ADDENDUM No. 3
FOR
LINK – Multi-Use Development
BID PACKAGE – All Trades

Date of Issue: April 24, 2023

LINK – Addendum #3 Narrative

4/21/23

P103

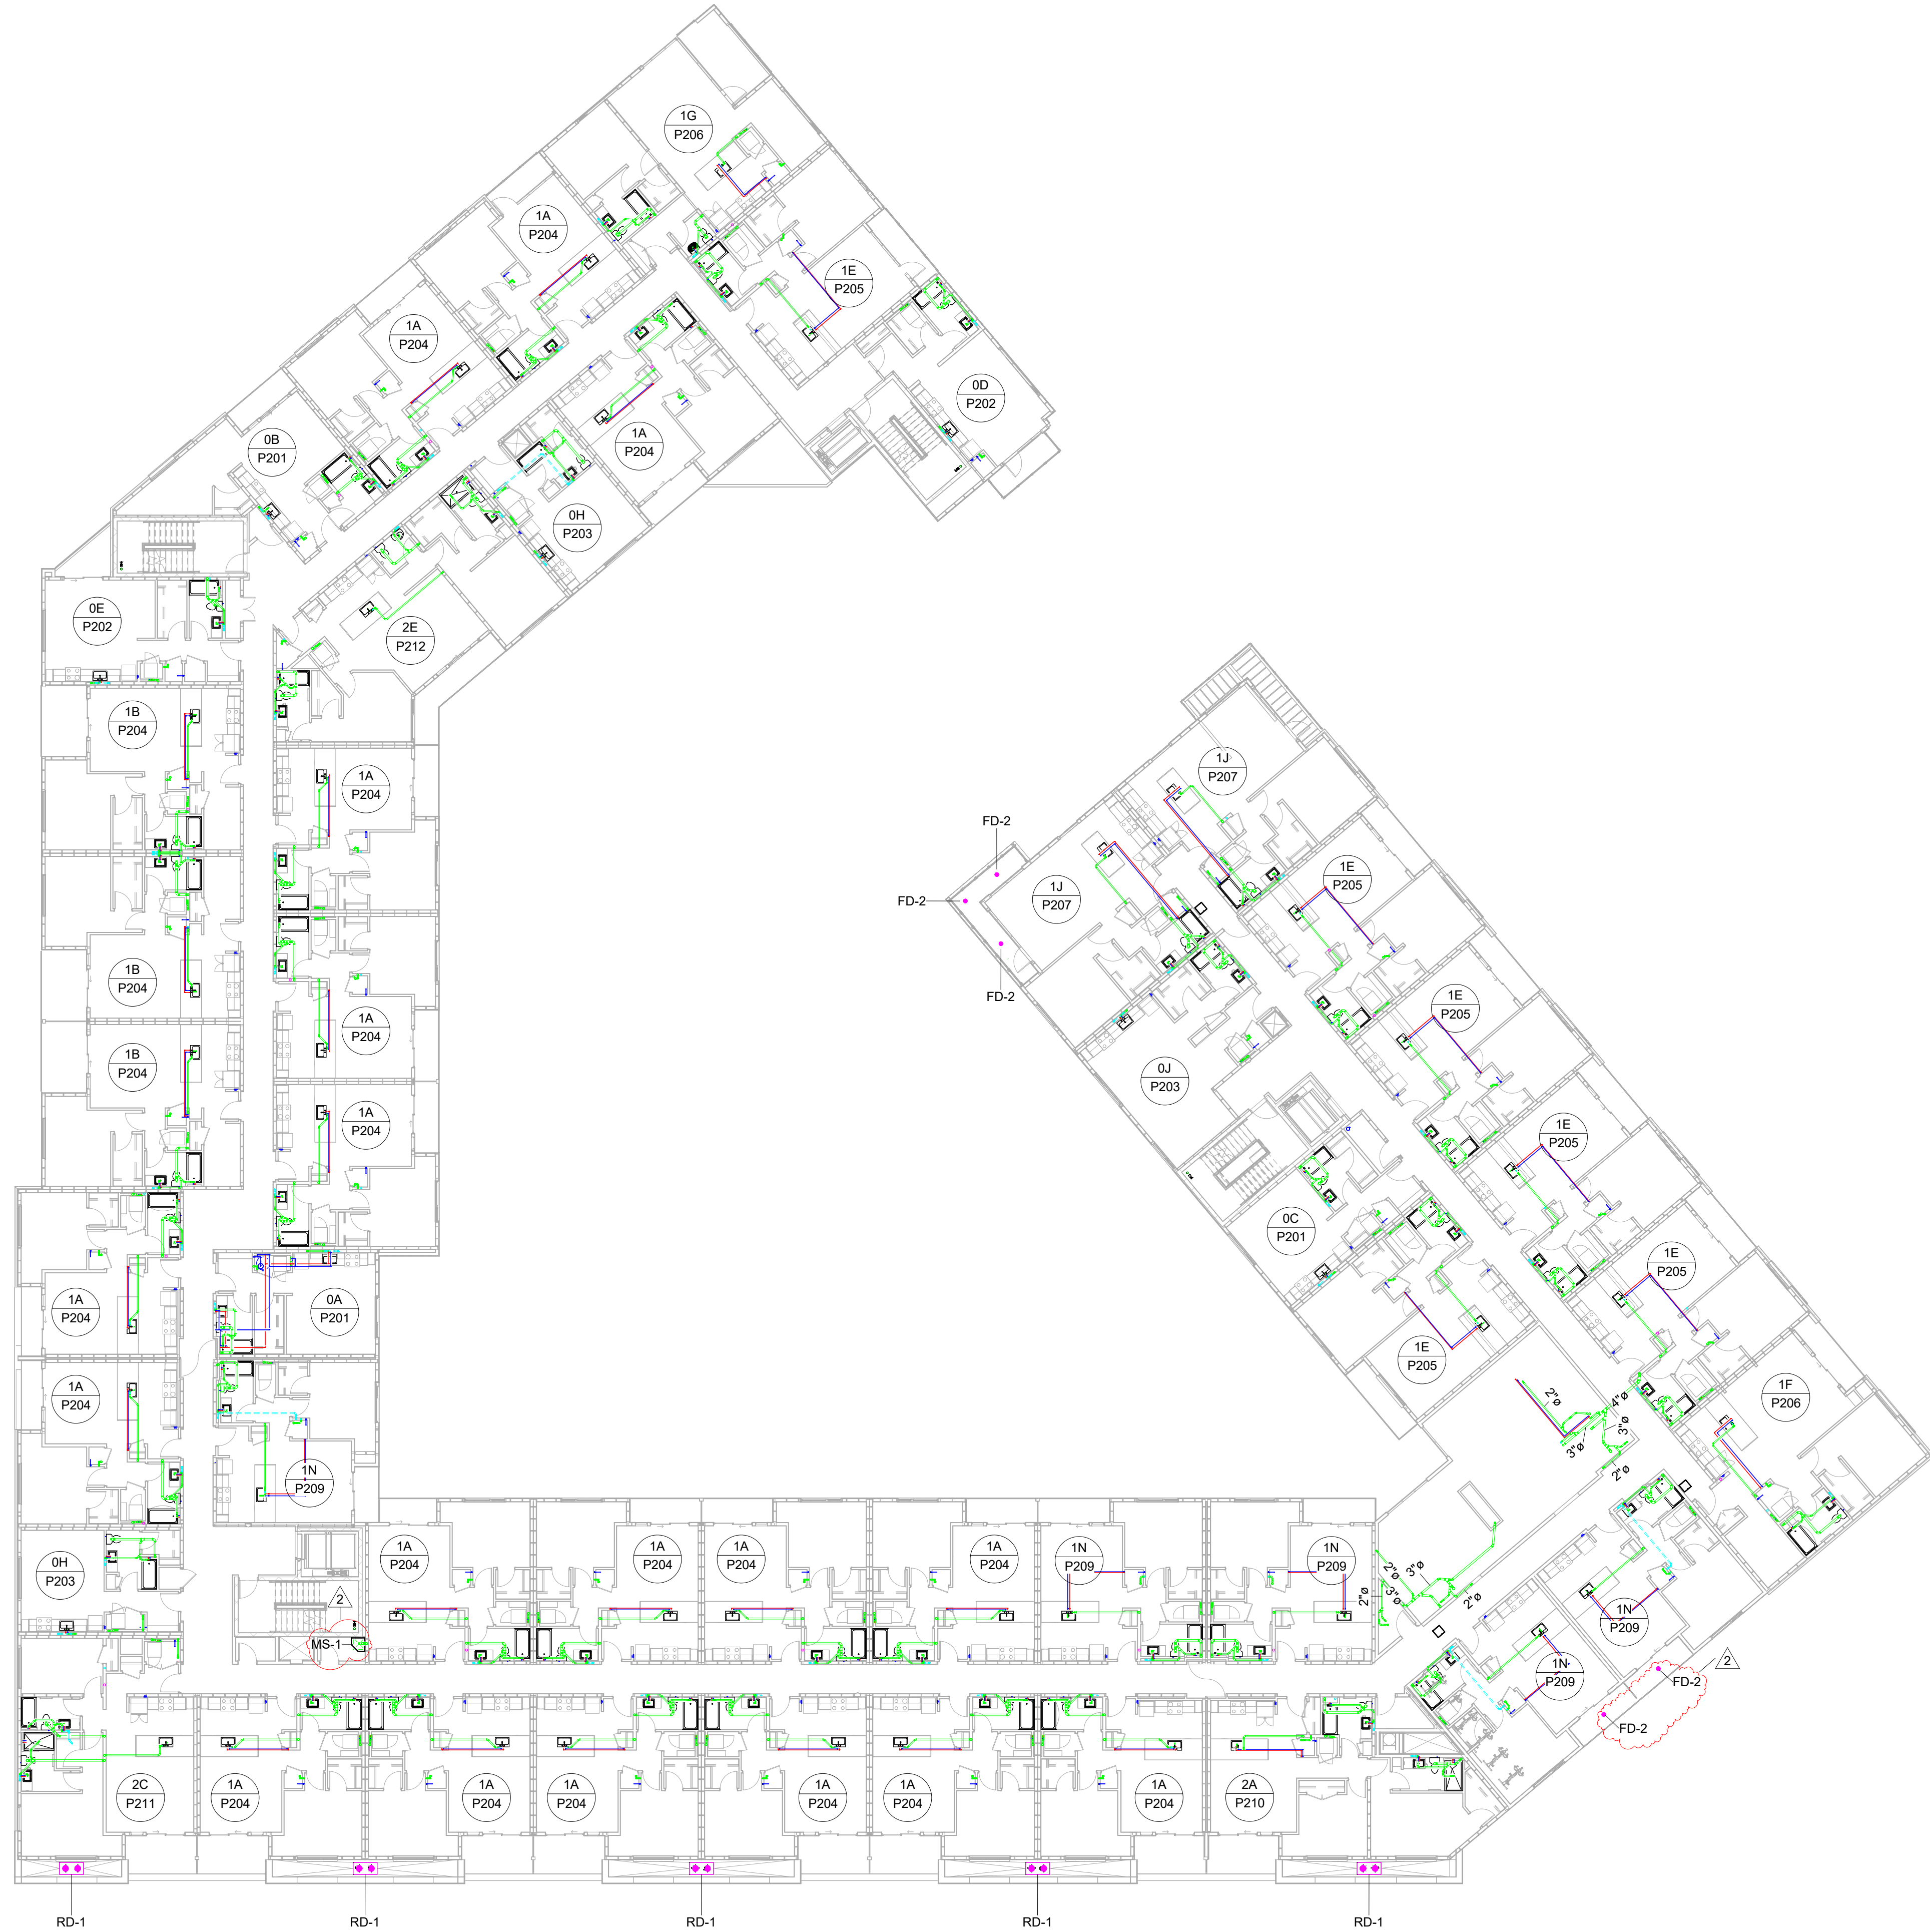
- P102
 - Storm piping added for unit 1N balcony drains.
 - Mop sink picked up.
 - P103
 - Floor drains added to unit 1N balconies.
 - Mop sink picked up.
 - P104
